**Town of Kittery
 Planning Board Meeting
 April 12, 2018**

Estes Business Park – Sketch Plan Review

**Re: Sketch Plan Application
Estes Business Park
U.S. Route 1**

PLAN AND PROFILE
ESTES BUSINESS PARK
U.S. ROUTE 1, KITTERY, MAINE

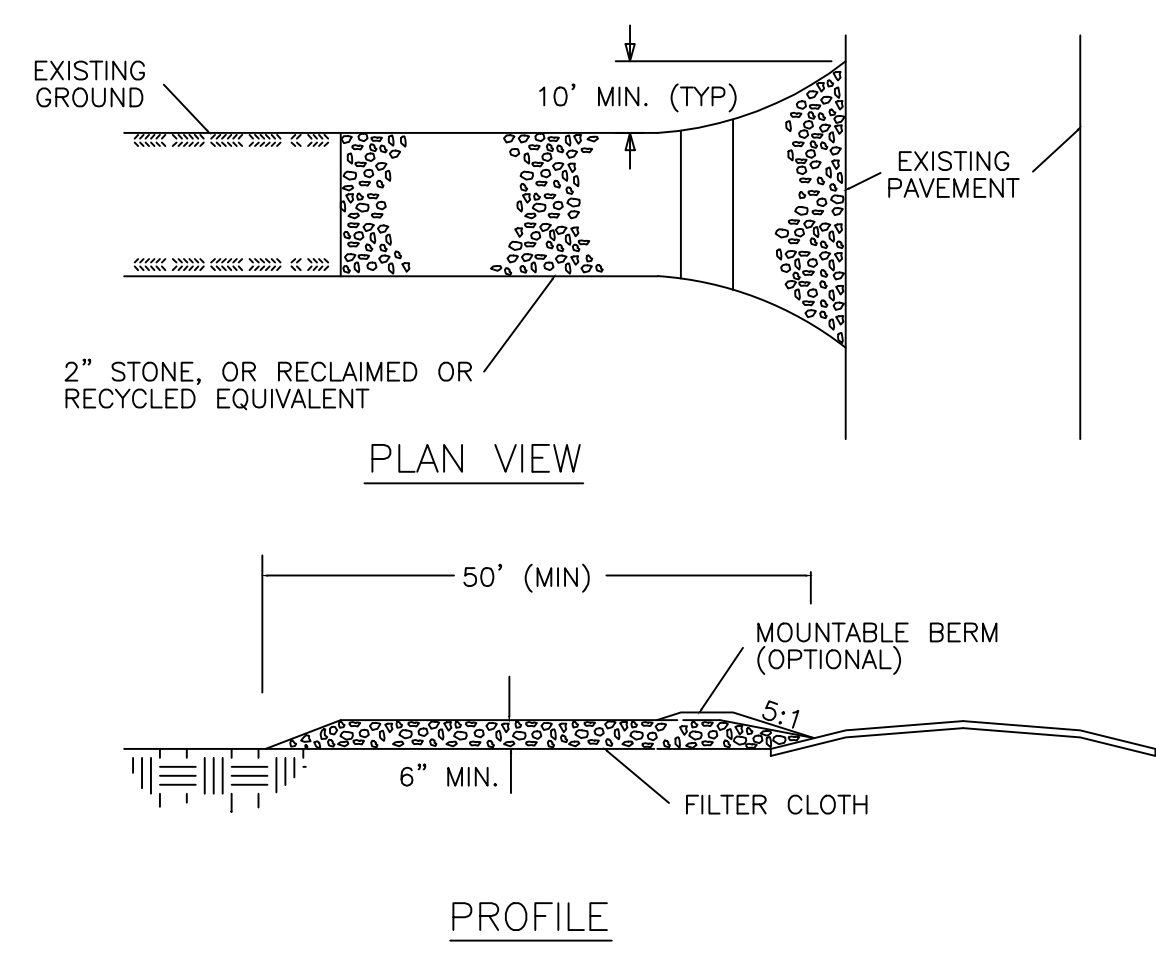
10. As defined by 16.8 Table 1, based on the mixed-use proposed for the site, the road would need to be a secondary collector road. The road proposed is 20 feet wide with 3 foot grass shoulders which does not meet the Town's standards for a secondary collector road. If the Applicant agrees to keep the road private, the Board may find that a road of that size is not necessary as long as the Public Works Commissioner and the Fire Department finds the road design acceptable. The applicant may wish to seek a waiver for road design.

The facility will be a low-volume traffic generator. Traffic generation is estimated at 24 vehicle trips/peak (P.M.) hour. The Institute of Traffic Engineers (ITE) Code 151 "Mini-Warehouse" and Code 770, "Business Park" were used in the analysis; (0.26 trips/unit/1,000 SF X 17,200 SF mini-storage) + (1.29 trips/unit/1,000 SF X 14,400 SF business park units) + 1 trip/managers apartment = 24 trips. Average Daily Traffic (ADT) is estimated at & 7 trips (storage units) + 48 trips (offices/shops) + 6 trips (manager's unit) = 61 trips/day. Peak daily traffic for the storage units will occur on a Saturday while the office/shops units are expected to generate peak traffic on weekdays. Table 1, Chapter 16.8 requires commercial, light-industrial and mixed use development streets to be constructed at no less than secondary collector standards. The proposed access road meets these standards with the exception of a 6' sidewalk and 6" of subbase gravel is proposed instead of crushed gravel.
